ENERGY COMPLETE MONOGRAPH

**2021 PUBLIC INPUT TO THE 2021 IECC, IRC CH. 11 AND
ICCPC CH.15**

Publication Date: November 2021

FIGURE C301.1 CLIMATE ZONES

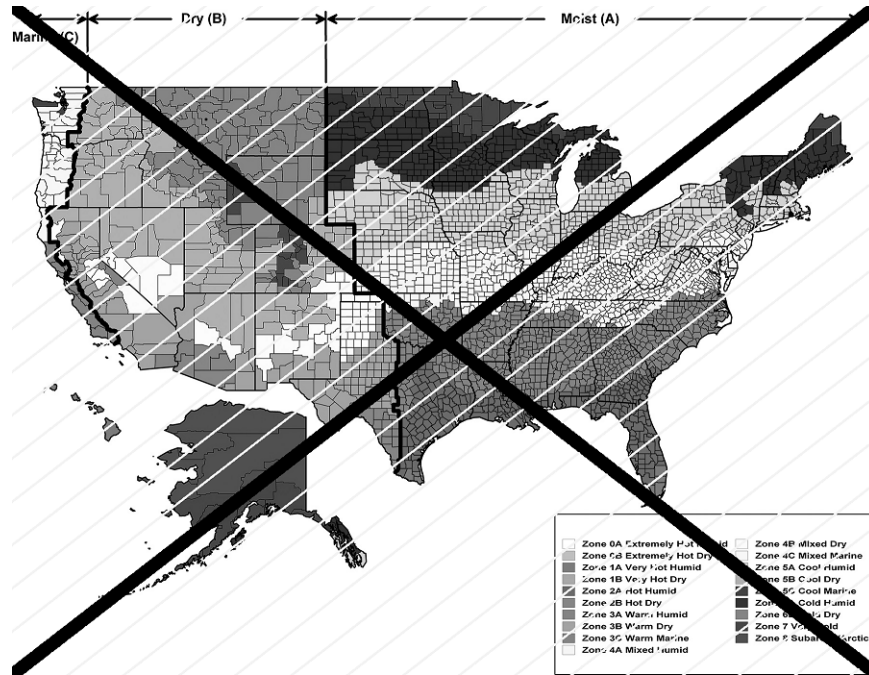
Delete without substitution:

Climate zones shall be as specified in R301. from Figure G301.1 or Table G301.1 shall be used for determining the applicable requirements from Chapter 4. Locations not indicated in Table G301.1 shall be assigned a *climate zone* in accordance with Section G301.3.

The code change proposal will decrease the cost of construction.

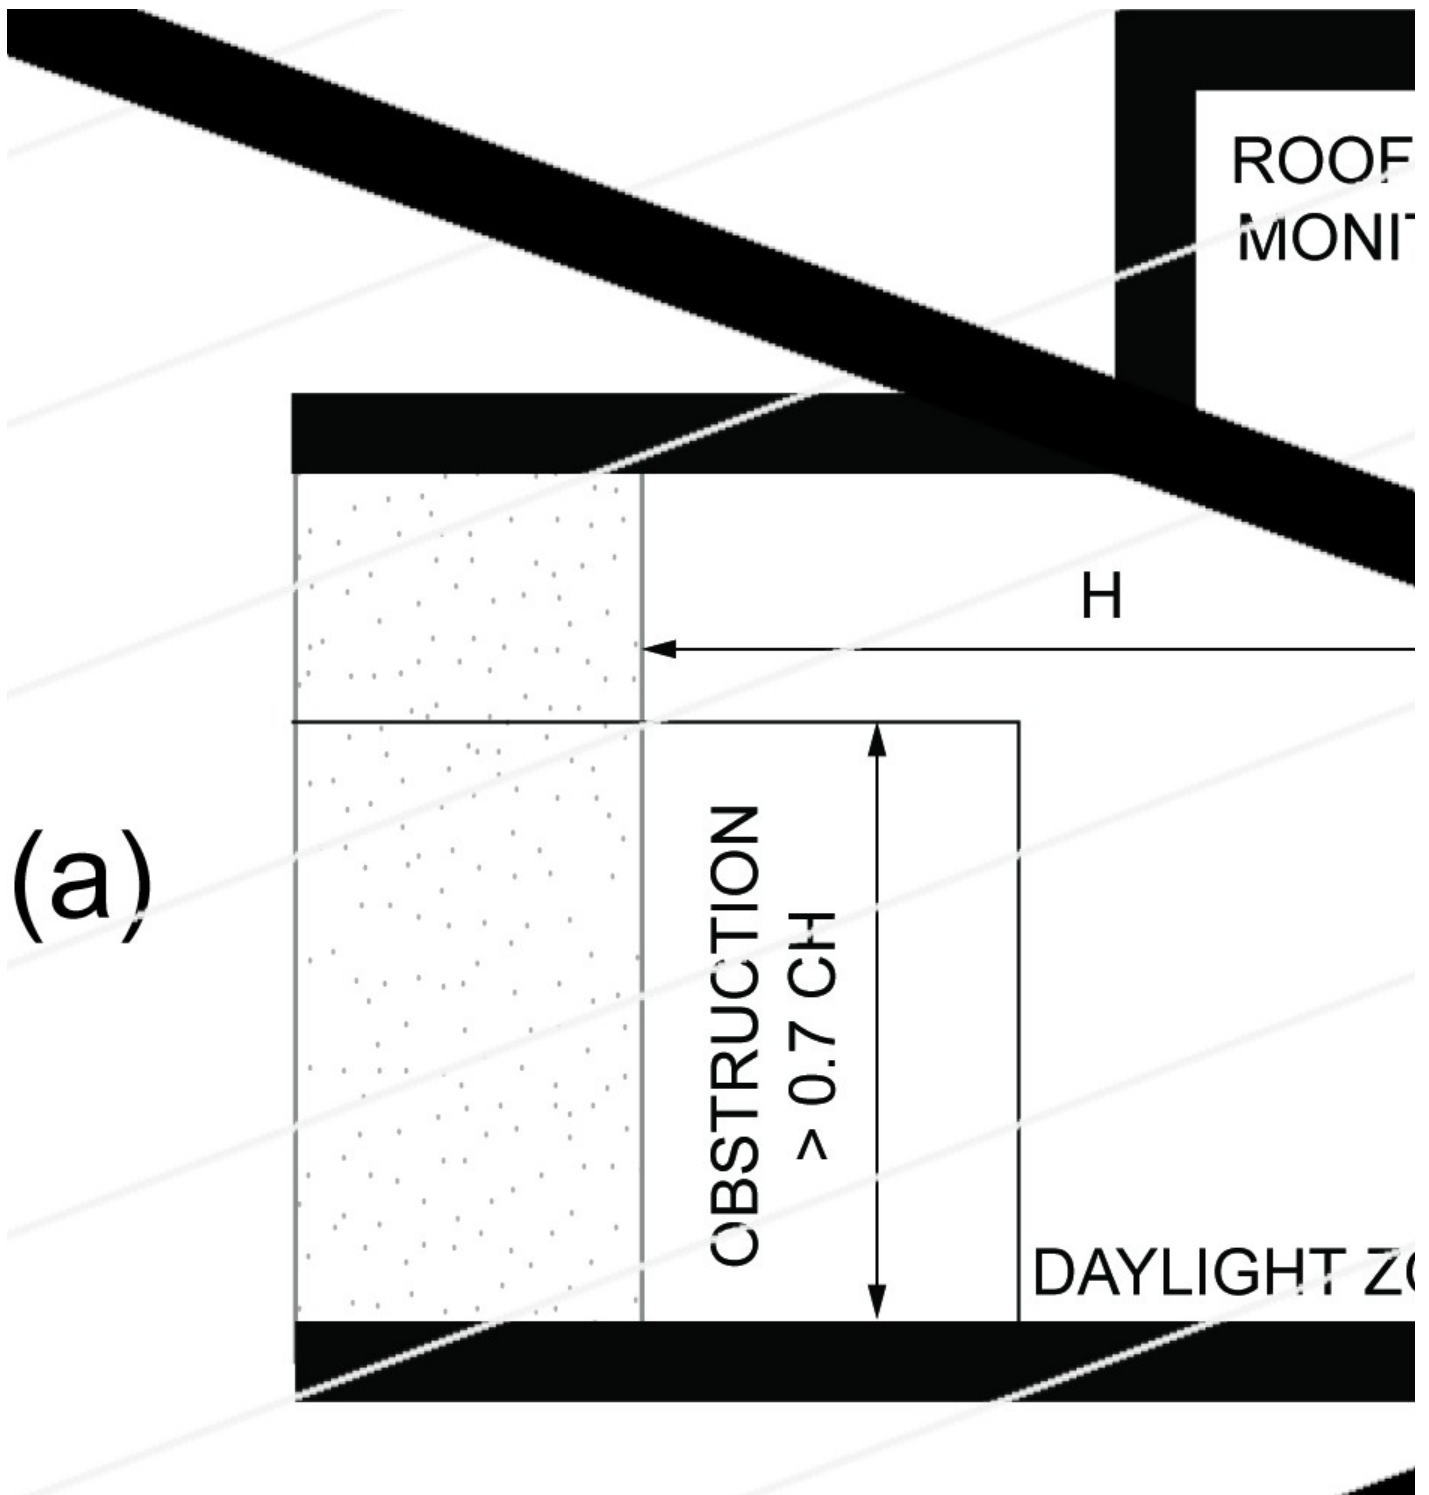
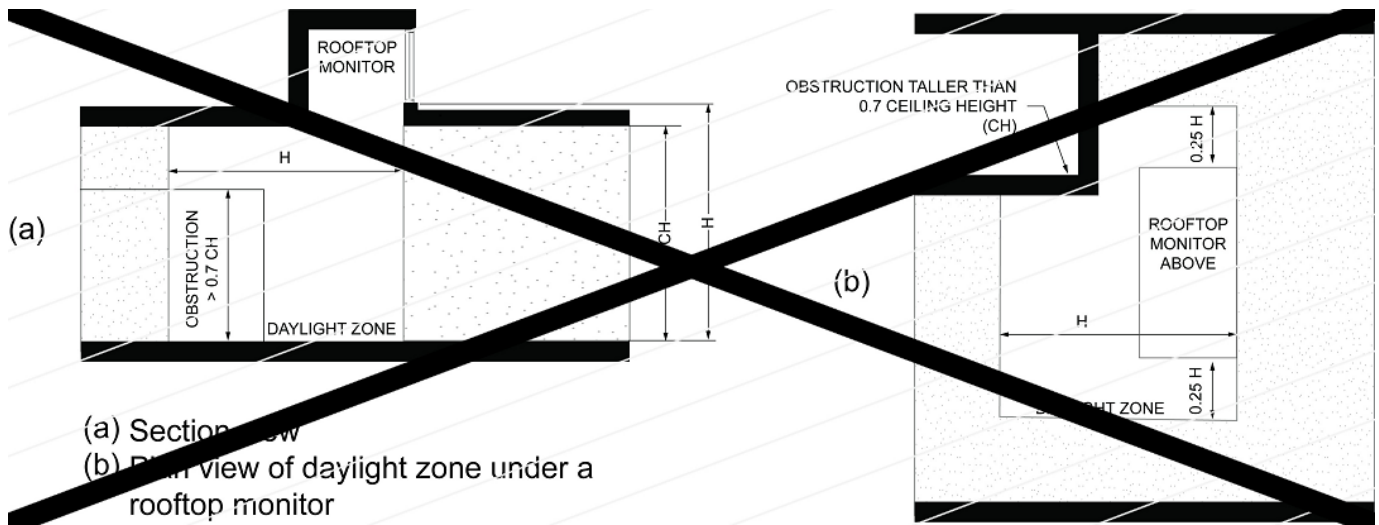
Reason Statement:

Darren Meyers, P.E., representing International Energy Conservation Consultants LLC (dmeyers@ieccode.com)

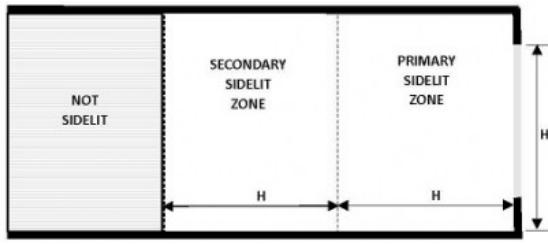
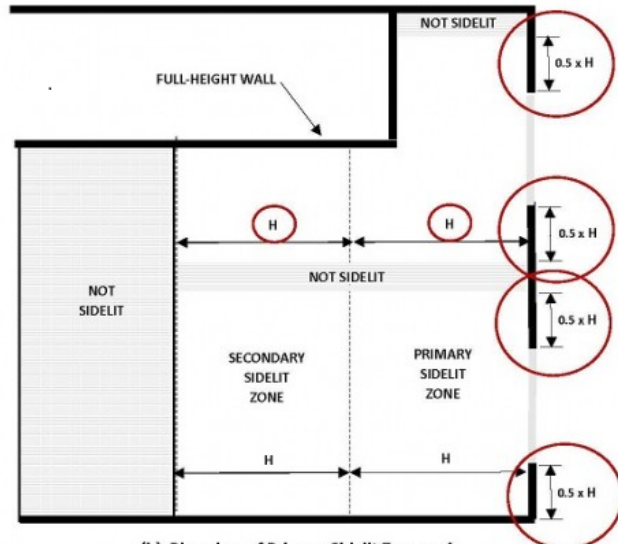
IECC®: CHAPTER 2 [CE], SECTION C202, SECTION 202 (New), C402.1.3 (New)

The code change proposal will decrease the cost of construction.
